SUNDRY NOTICES AND REPORTS ON WELLS Farmington Field Office #63A
Do not use this form for proposals to drill or to re-enter an abandoned well. Use Form 3160-3 (APD) for such proposals.

8. Well Name and No.
Rosa Unit #63A

PLUG AND ABANDONMENT PROCEDURE

CONDITIONS OF APPROVAL

**ROSA UNIT #063A – Proposed P&A
Horizontal ReEntry
BASIN FRUITLAND COAL**

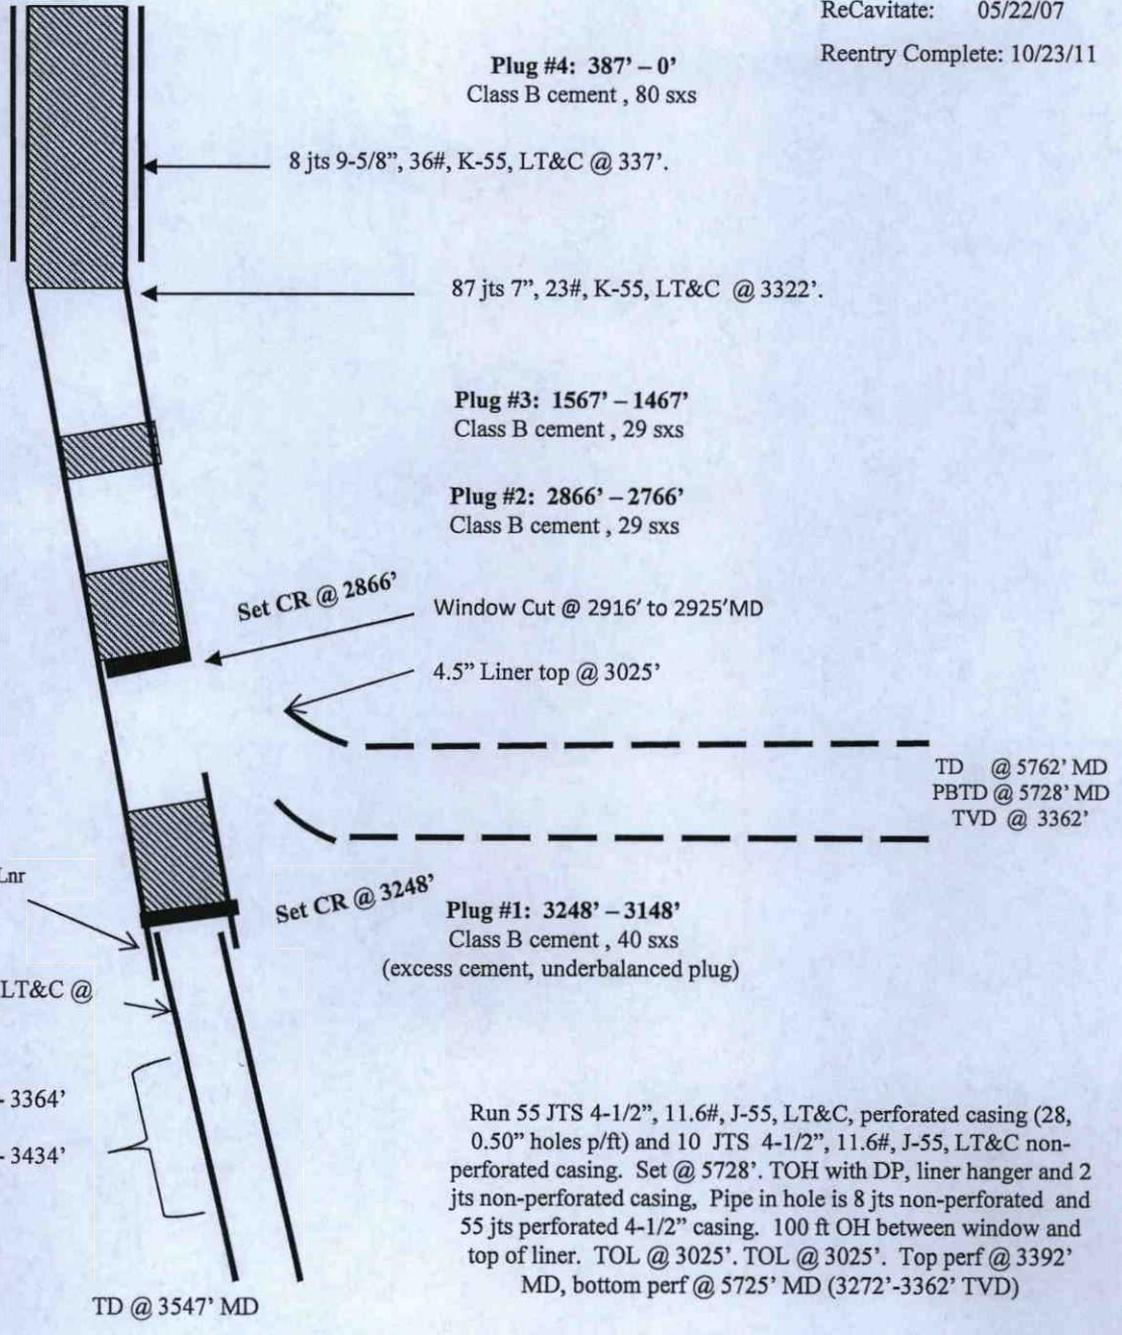
- a) Set plug #1 (3272-3172) ft. to cover the Fruitland top. BLM picks top of Fruitland at 3222 ft.
- b) Set plug #3 (1577-1477) ft. to cover the Nacimiento top. BLM picks top of Nacimiento at 1527 ft.
